ADDENDUM NUMBER 1

- 1.01 DATE: April 7, 2015
- 1.02 PROJECT: Interior Renovations to the Mimosa - G Residence
Ramapo College of New Jersey
- 1.03 SNS PROJECT NUMBER: 4698G

INTERIOR RENOVATIONS
AT THE
MIMOSA - G RESIDENCE

ENLARGED SECOND FLOOR PLUMBING DEMO PLAN
SCALE: 1/4"=1'-0"

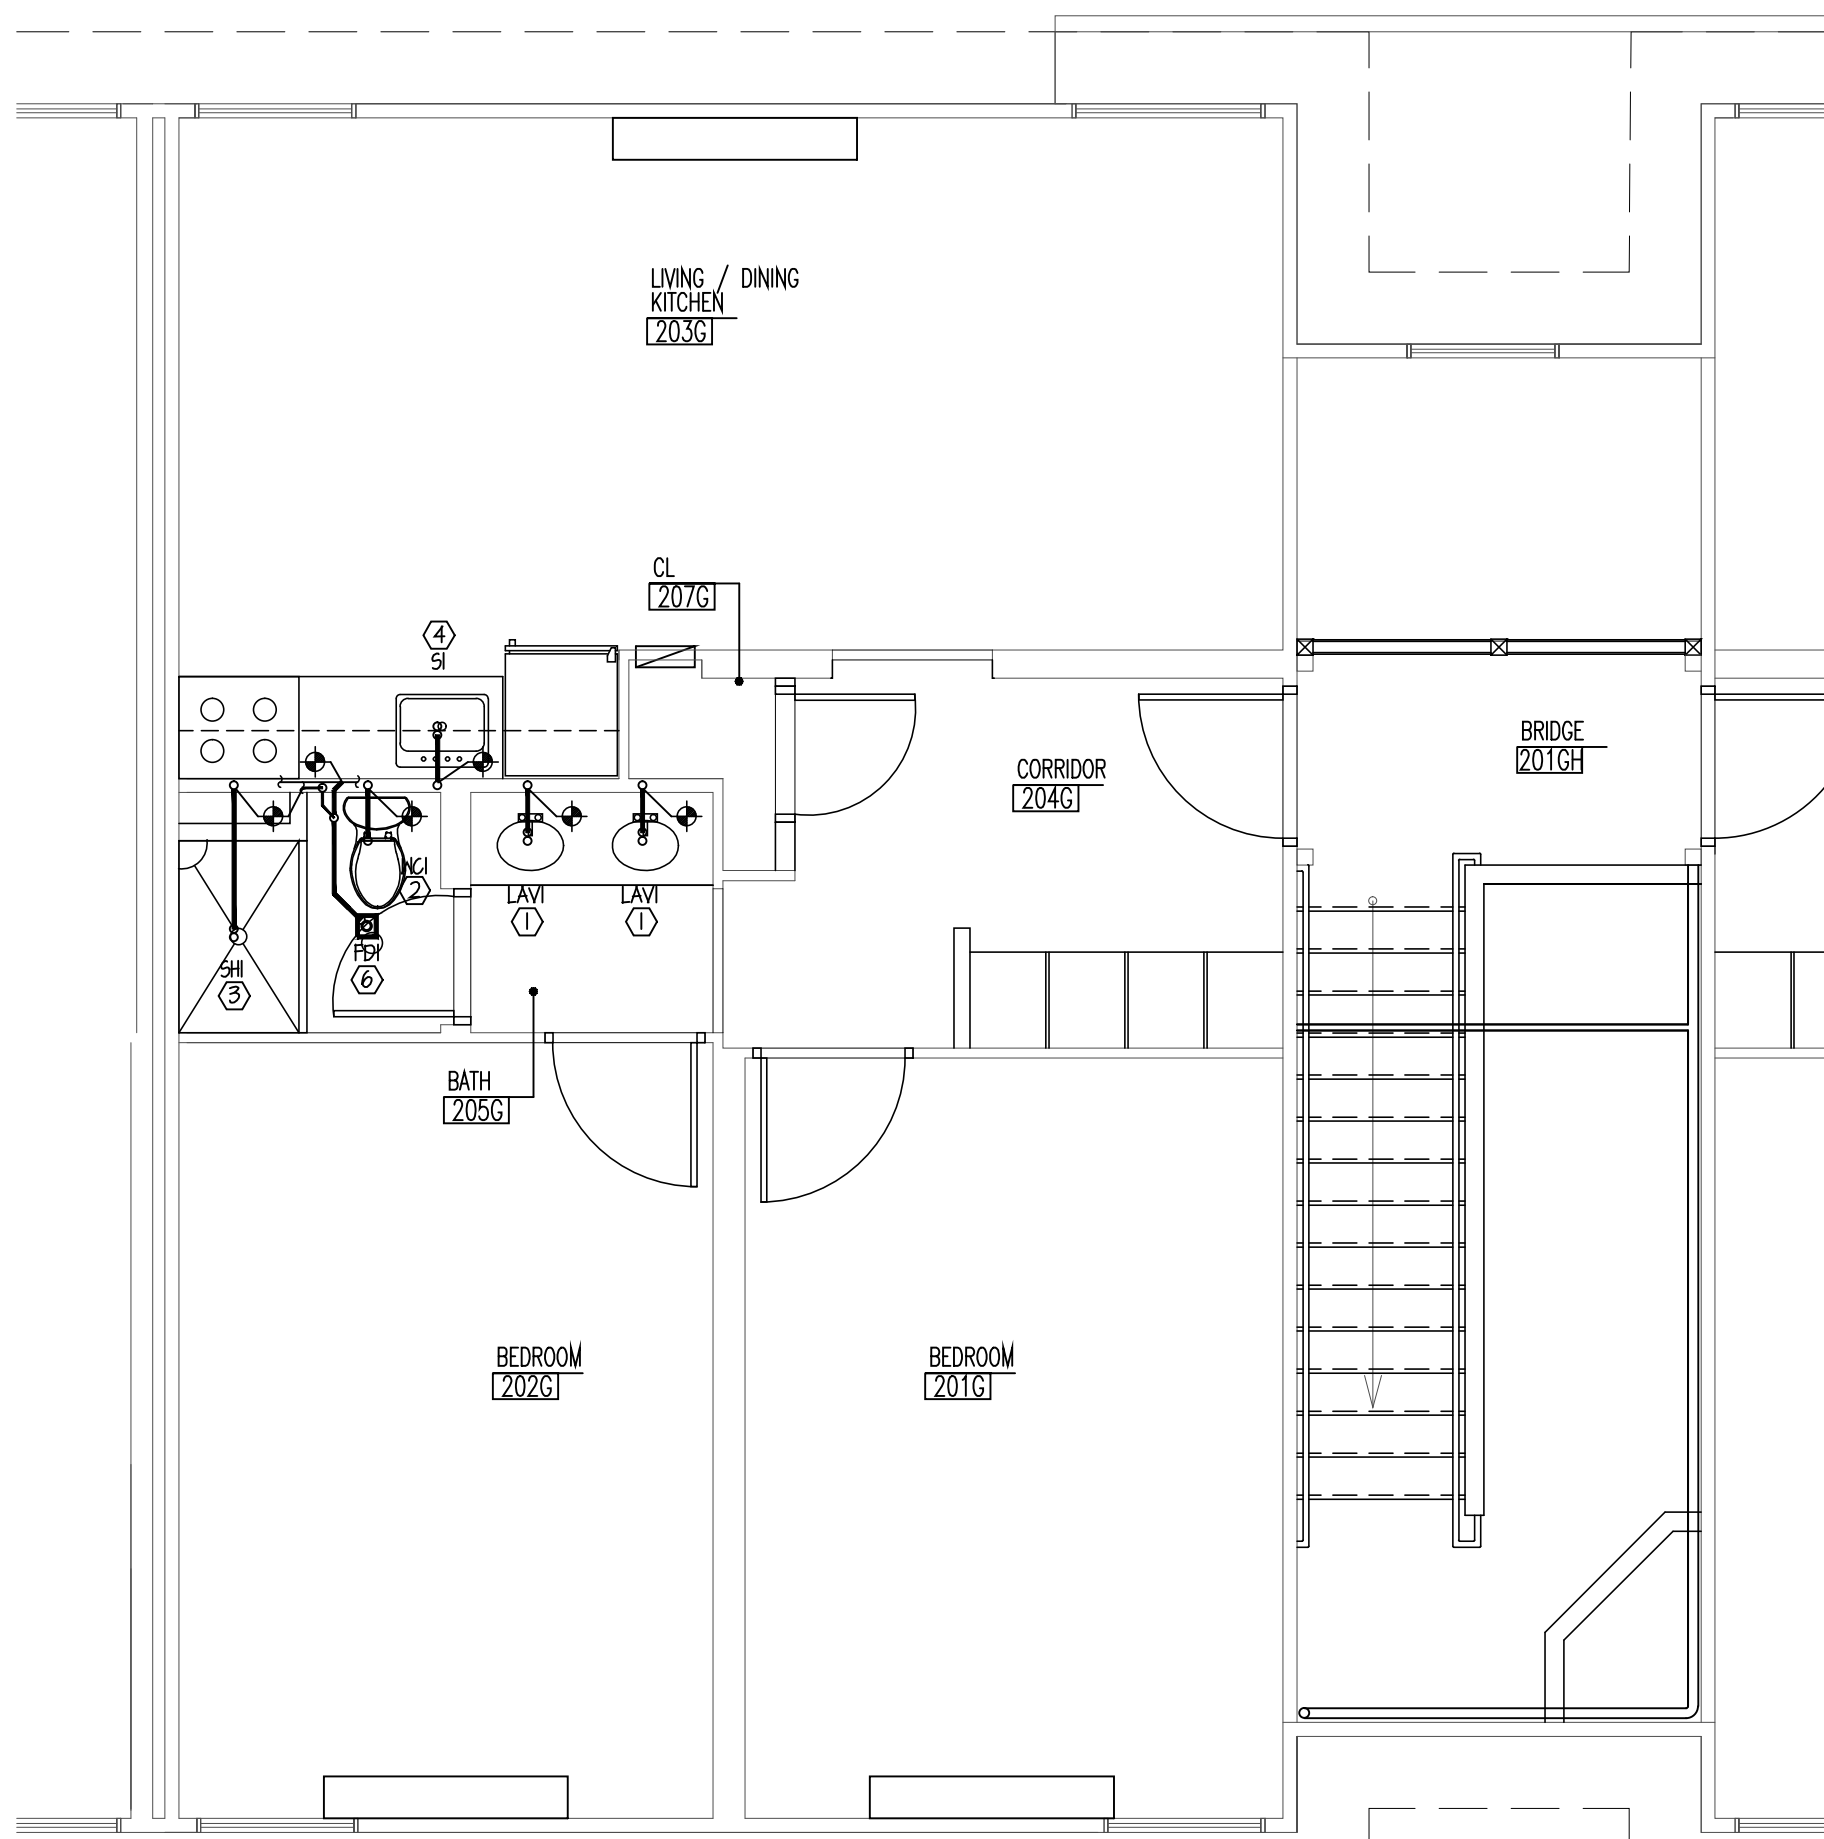
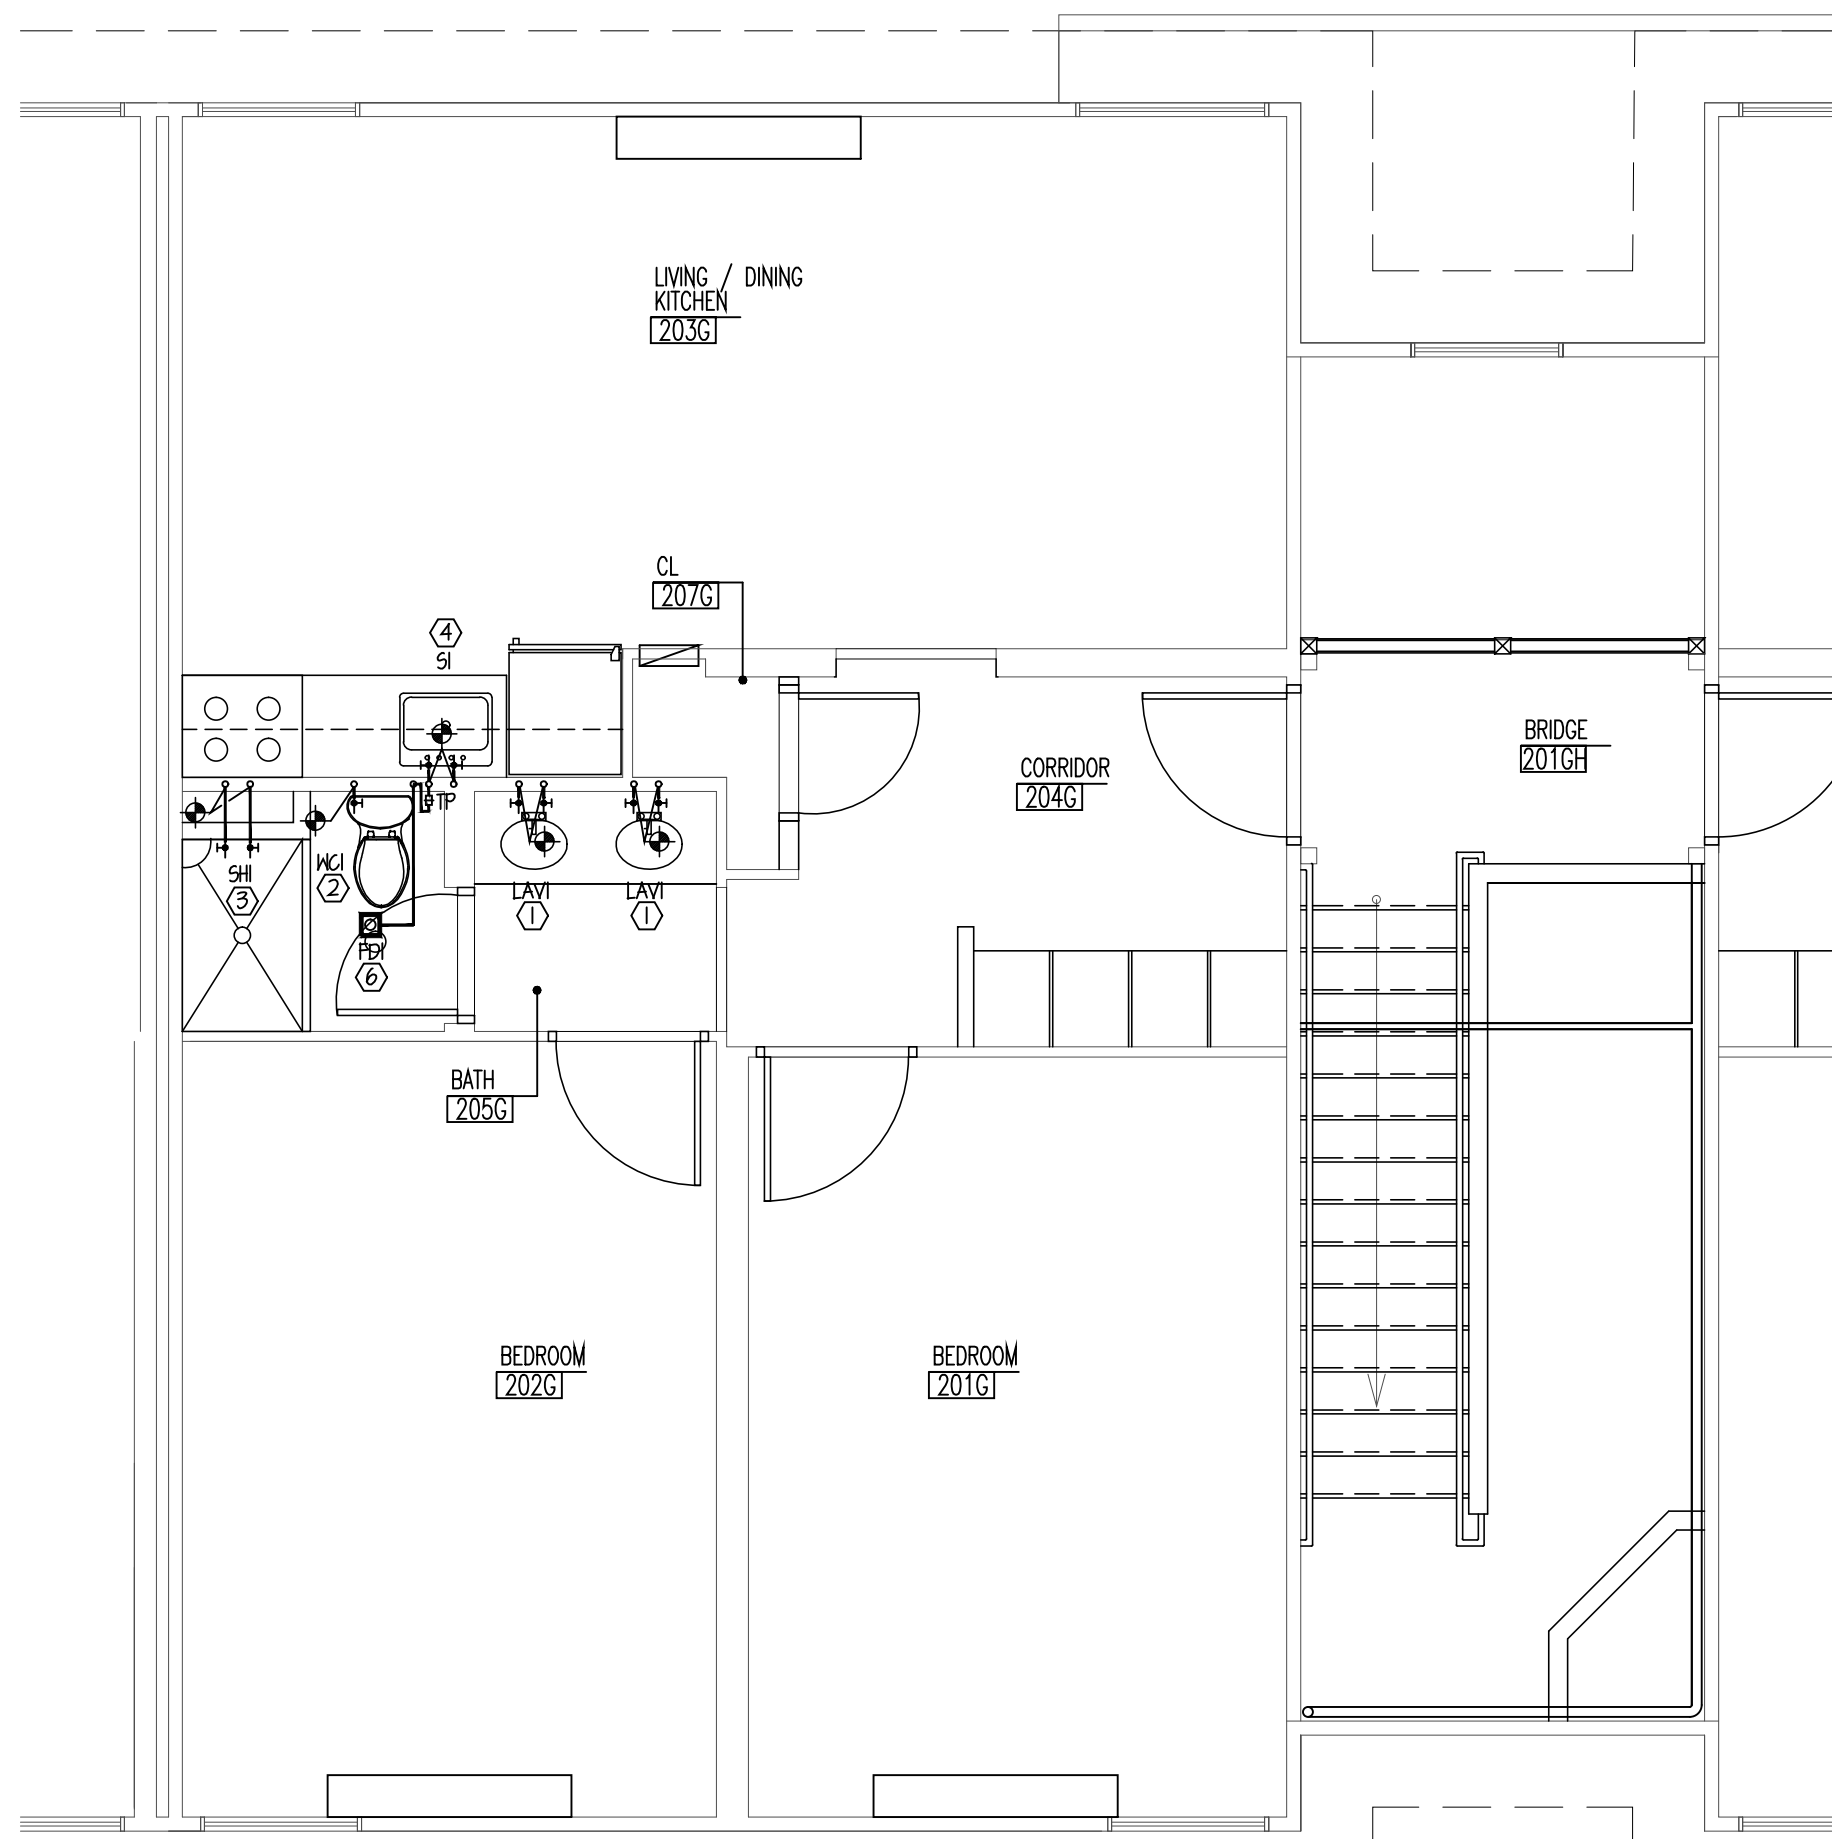
- 7.1. Added note indicating that all demolition work is by others under separate contract and filed under separate DCA permit application.
